ADDENDUM NO. 2

Date: January 5, 2015
Project: City of Tuscaloosa
Cedar Crest Drainage Structure Project
Project No. A13-0580

CITY OF TUSCALOOSA
CEDAR CREST DRAINAGE STRUCTURE PROJECT
(CITY PROJECT NO. A13-0580)

DWG. No. 503-13
SHEET No. C6.8

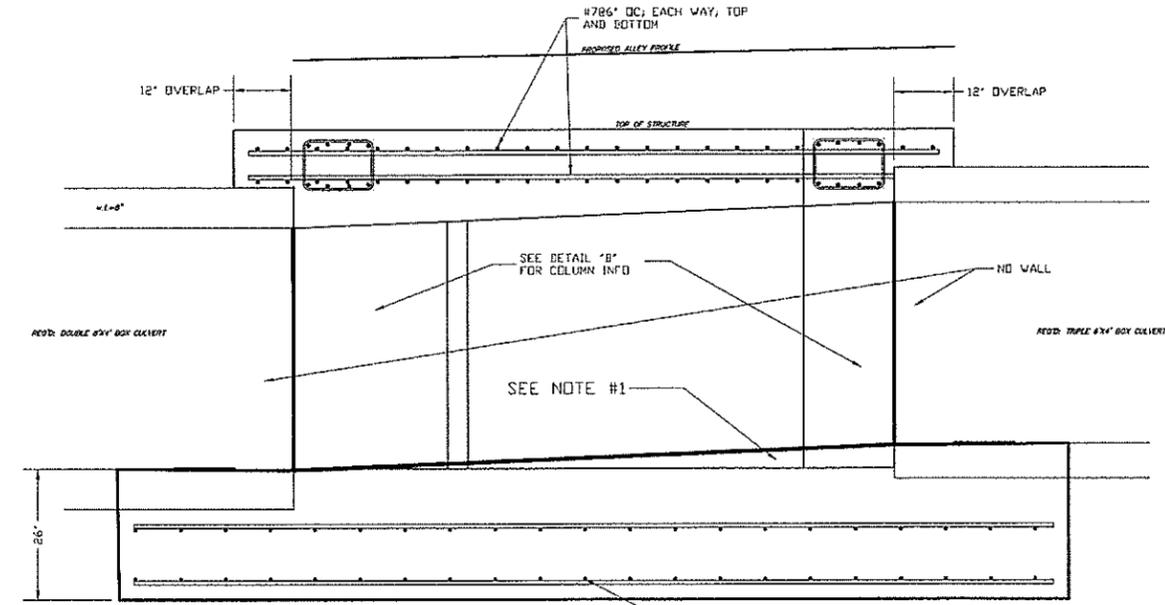
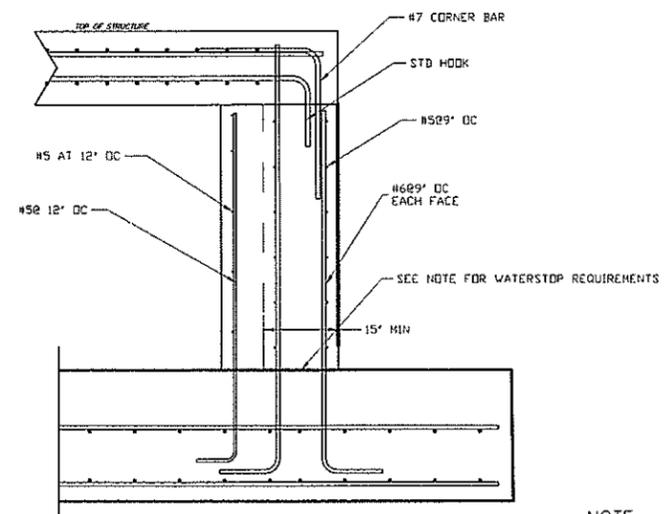
Dimensions have been revised on the attached Sheet C6.8.

FILE NAME: C01-CedarCrest-DETAILS	SCALE: 1/4" = 1'-0"	DWG. No.	SHEET No.
DATE OF FIELD SURVEY: N/A	FIELD BOOK: N/A	DRAWN BY: K.S.W.	503-13 C6.2
SUB No. 13-2387	PAGE: N/A	CHECKED BY: J.L.D.

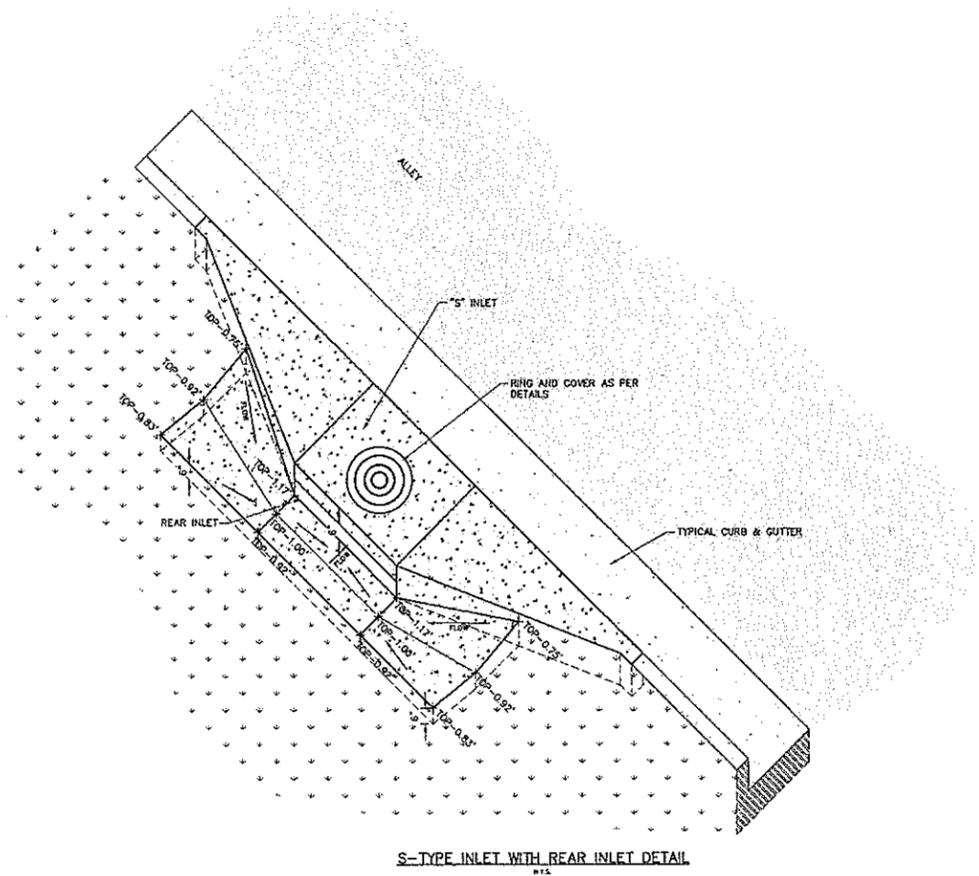
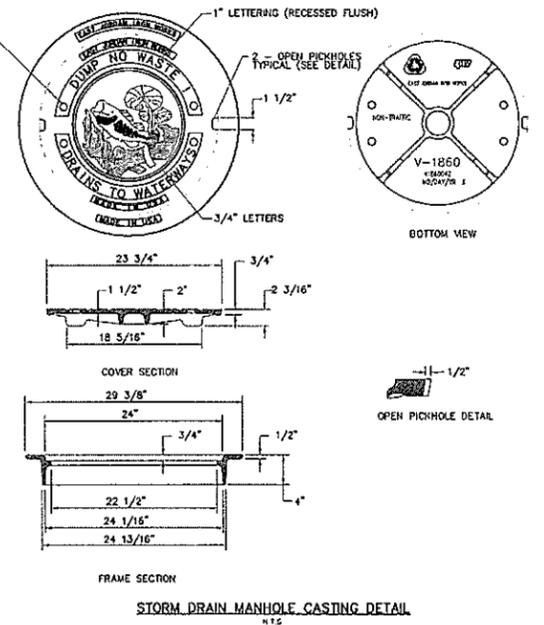
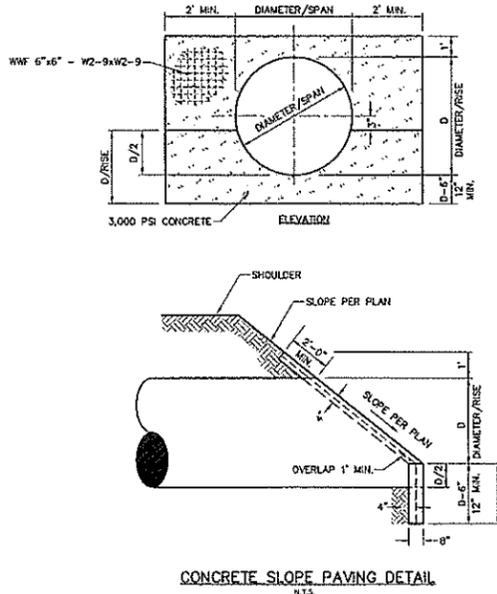
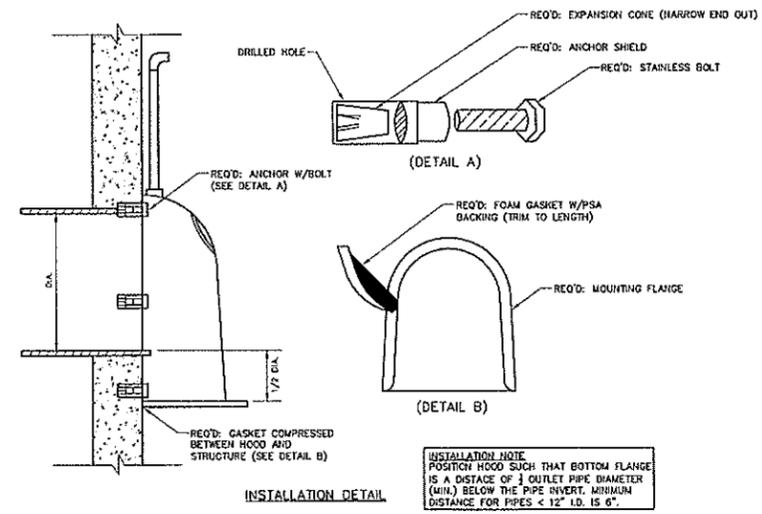
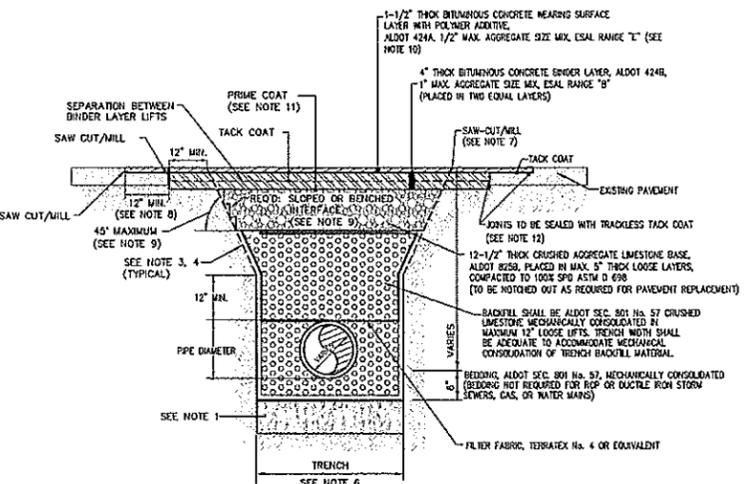
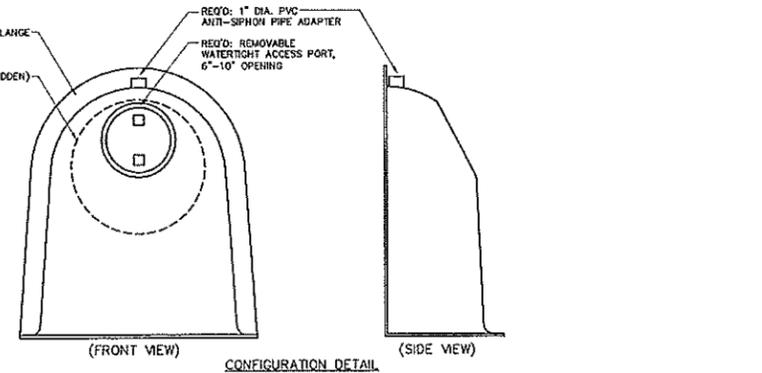
A detail has been added to Sheet C6.2 for additional reinforcing on drainage structure #2.

REVISION		
DATE	DESCRIPTION	BY
1/2/15	ADDED PIPE REINFORCING DETAIL	J.D.

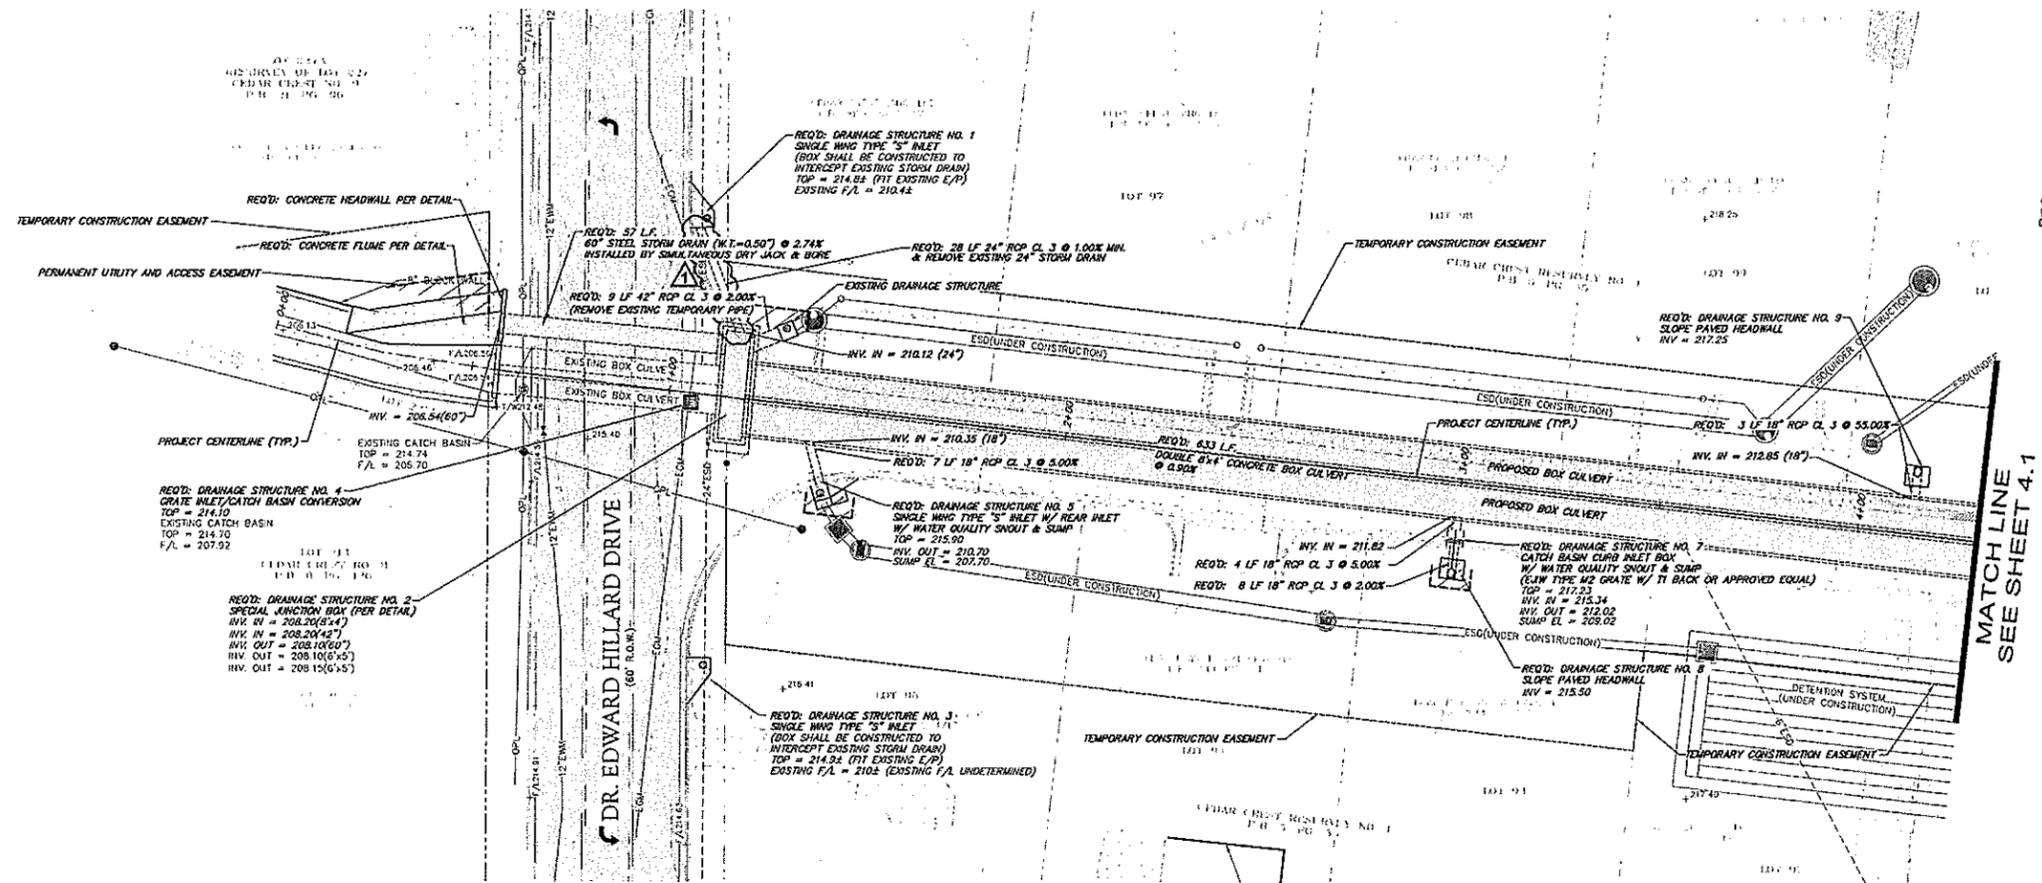
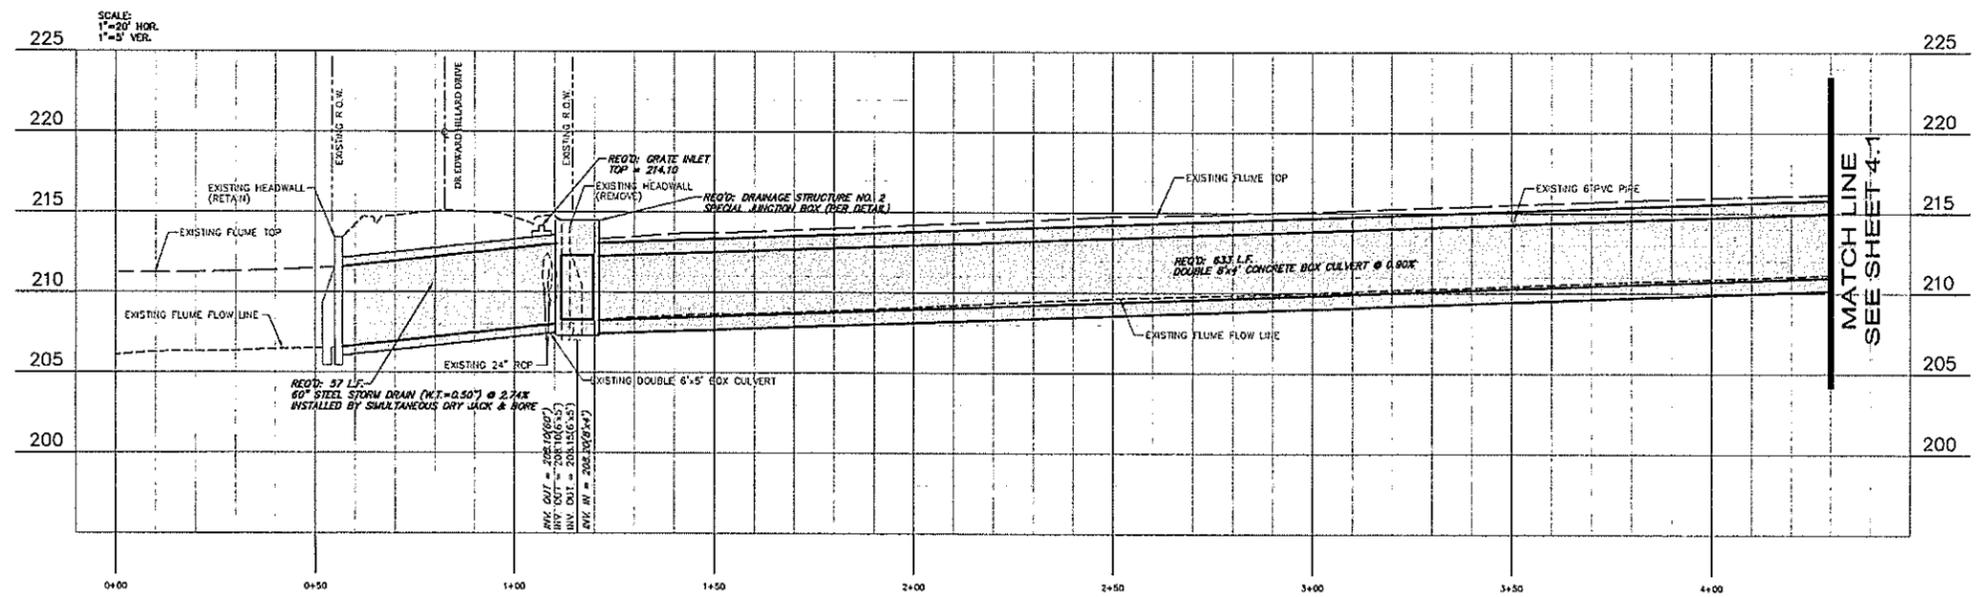
Sheet C4.0 has been revised to include 28 l.f. of 24" RCP North of drainage structure #2. The bid schedule has also been revised to reflect this addition.
